13 June 2022

**Submission with regard to Development Application DA2022/0448
Subdivision of one lot into two and partial demolition of existing dwelling
7 Cooleena Road, Elanora Heights, NSW**

I write regarding the above Development Application DA2022/0448 (subject DA) to make a submission on behalf of Mr and Mrs Kirby at 5A Cooleena Road (my clients).

Figure 3 – Geotechnical Hazard Map

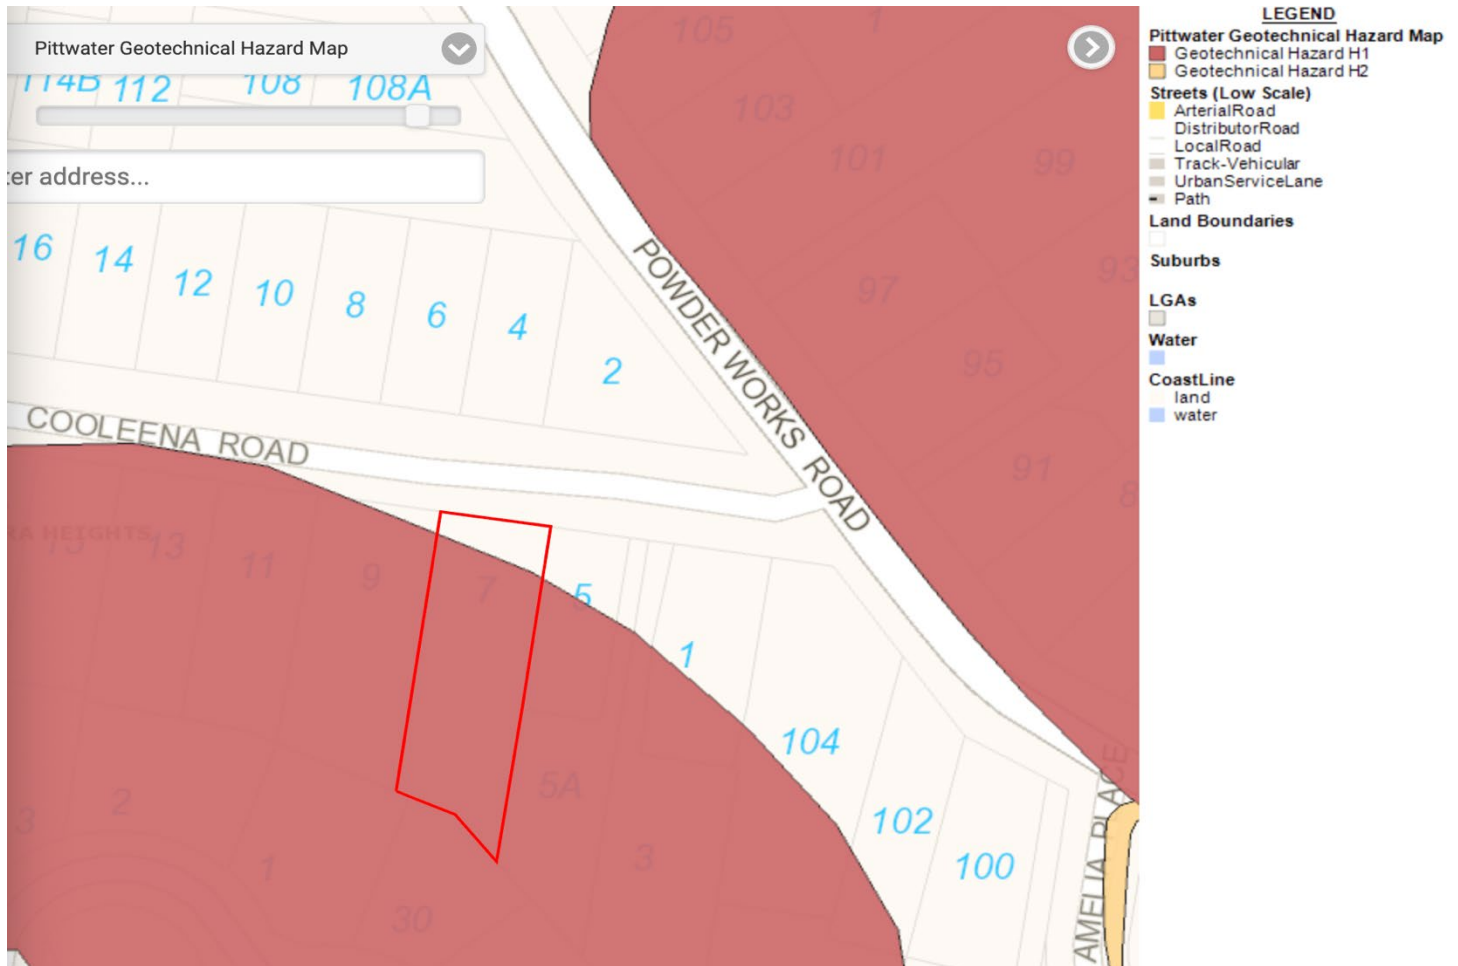
Clause 7.7 Geotechnical hazards

A Geotechnical Report has been submitted with the Development Application and risks to neighbouring and future occupiers should be fully assessed as part of this application. The fall of the land varies from 9 degrees to 30 degrees and a steep escarpment drop is set within the subject site towards the rear boundary line. The levels at the bottom of the escarpment drop off are not clearly annotated on the survey plan, although a site visit from my client's property would facilitate an appreciation of the significant fall in the land.

The subject site is located within Hazard Zone 1 of the Pittwater Landslip Risk, which indicates a possibility of a landslide events as, 'possible to almost certain'.

The Geotechnical Report submitted to support the proposed subdivision, identifies the risks with regard to soil instability and implications of full stormwater discharge given the topography to the site and escarpment drop off to the rear. However, the findings and potential risk to life implications are addressed by recommendations and stated limitations. As geotechnical assessment and stormwater management is not by area of expertise and given the significant risks to life, it is requested that Council Engineers are fully satisfied with the level of information submitted and associated risks to both neighbouring and future occupiers.

Although the proposed development is for the subdivision of the land, the implications from a stormwater and geotechnical assessment needs to take into account the impact of the future built form of the subject site, in accordance with Cl.4.1 and 7.7 of the LEP.
